**Subject:** FW: DC/24/1452/RM | Reserved matters application - a. submission of details under DC/15/2151/OUT for access, appearance, landscaping, layout, and scale of the local community centre (Class F2(b)) within Parcel D1 pursuant to outline permission DC/15/

**Subject:** DC/24/1452/RM | Reserved matters application - a. submission of details under DC/15/2151/OUT for access, appearance, landscaping, layout, and scale of the local community centre (Class F2(b)) within Parcel D1 pursuant to outline permission DC/15/2151/OUT,

Thank you for your consultation on this Reserved Matters application DC/24/1452/RM for the Zone D1 land in Haverhill. Suffolk County Council, as the Highway Authority, offer the following comments.

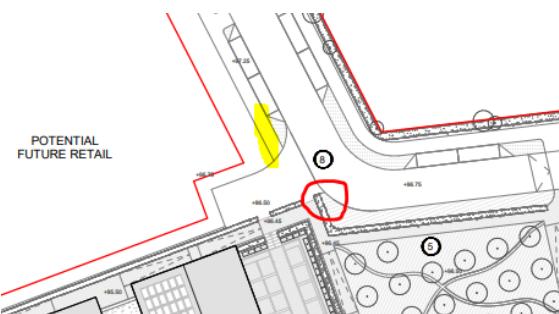
The Highway Authority notes that the development under consideration does not include the parcel of blue line land in the eastern section that is allocated to potential healthcare use or the parcel of blue line land in the northern section that is allocated to potential retail use.

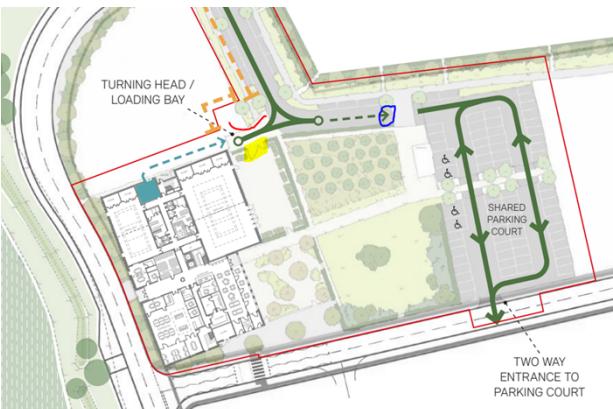
The snip below is taken from the Proposed Site Block Plan Drawing No. DR-A-300002 C1. The yellow highlighted route is the southern end of a footway which runs from Gurteen Avenue but the continuation on the southern side is not directly opposite which is unfortunate. This will be an important walking and wheeling route towards the development, and it would be desirable to ensure the route follows the desire line as closely as possible and doesn't introduce any pinch points, as may be the case with the continuation footway where there appears to be a narrowing between vegetation.

This part of the site will provide a vehicle turning head that will be used by refuse collection vehicles. The red circle in the snip below shows that there will not be a radius on the southern kerb line. Because this section of road is to be used for vehicle turning, this layout may be inconvenient and lead to kerb damage.

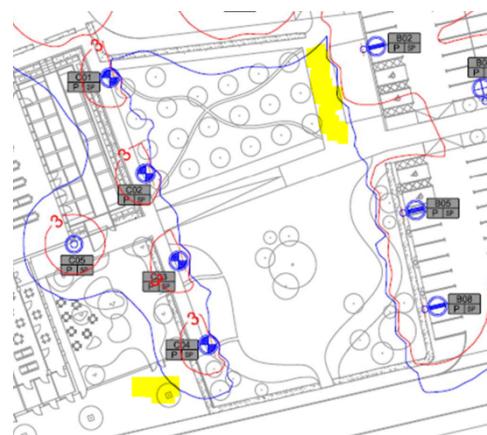
The snippet below is from the Design and Access section 9 showing the vehicular movement strategy. It shows the footway misalignment mentioned above, and also a gate (highlighted yellow) into an area to the south. It is assumed from the Site Plan and because of the level differences that there will be no vehicular movement through it.

The Highway Authority is not aware of a timeline to progress the future retail use, but we note the potential for the turning head to become the primary vehicle access into the future retail area (my red line).

It is not clear that the proposed road layout will be suitable for the much higher level of vehicle movement that would be generated by the future retail use. We suggest that it may be beneficial to construct the turning to the dimensions necessary for that future use. Will the future retail be serviced by HGV's reversing into a delivery yard? It appears that the proposed layout may not be suitable for those future manoeuvres, but track plans could clarify the issue. It would be undesirable to construct a road layout that requires modification in the foreseeable future. We note that the bend in Gurteen Avenue acts as a frontage constraint to another potential vehicle access.

There would also be a pedestrian desire line between the application site and a future retail offer. The layout of the turning head design may want to anticipate this walking and wheeling movement and bring forward further detail as part of this application.

The northern site road continues and connects to the main car park along a section that is proposed to be one-way. What measures are proposed to prevent drivers leaving the car park using this section (my blue circle)? There is likely to be a level of convenience that could be achieved by a driver going against the one-way to avoid the main car park exit. Is it necessary to have a vehicular connection to the car park like this? Why aren't all vehicles to the car park using the proposed two-way access?
